16 April 2021

RFI Response Letter - Dangar St Wickham 21200416.docx

## **Request for Further Information Response for DA2018/01197.02– 10 Dangar Street, Wickham NSW 2293**

**Figure 1 Public Art extract – West Elevation**

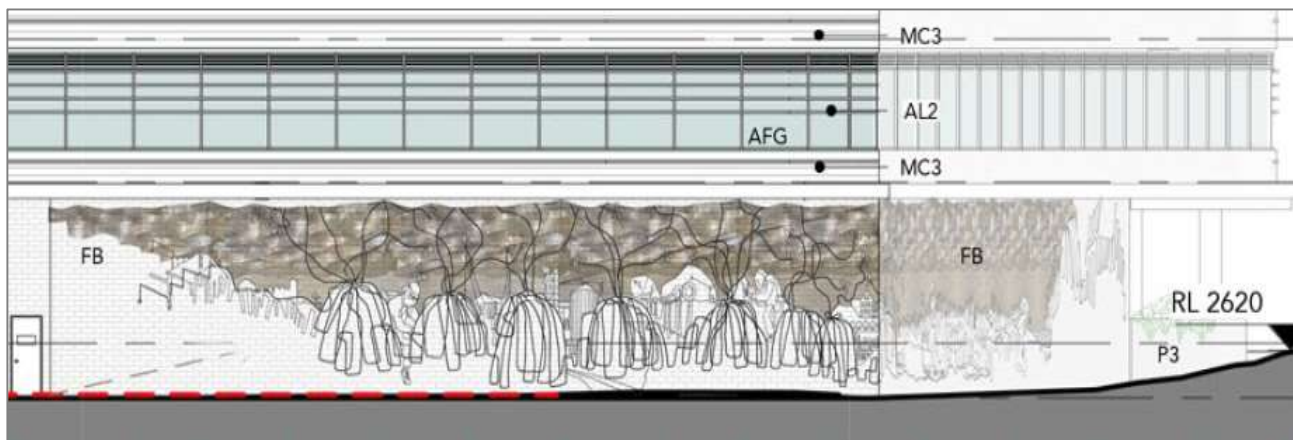
To further inform the consideration of public art to be installed, the nominated artists work has been overlaid on the elevation plans, demonstrating the location & extent of the proposed artwork. This additional detailing demonstrates that condition 4b) is intrinsically achieved through the requirements of 4a) and vice-versa, refer Enclosure D. An extract of the artwork overlaid on the architectural plans is detailed in Figure 1 and 2.
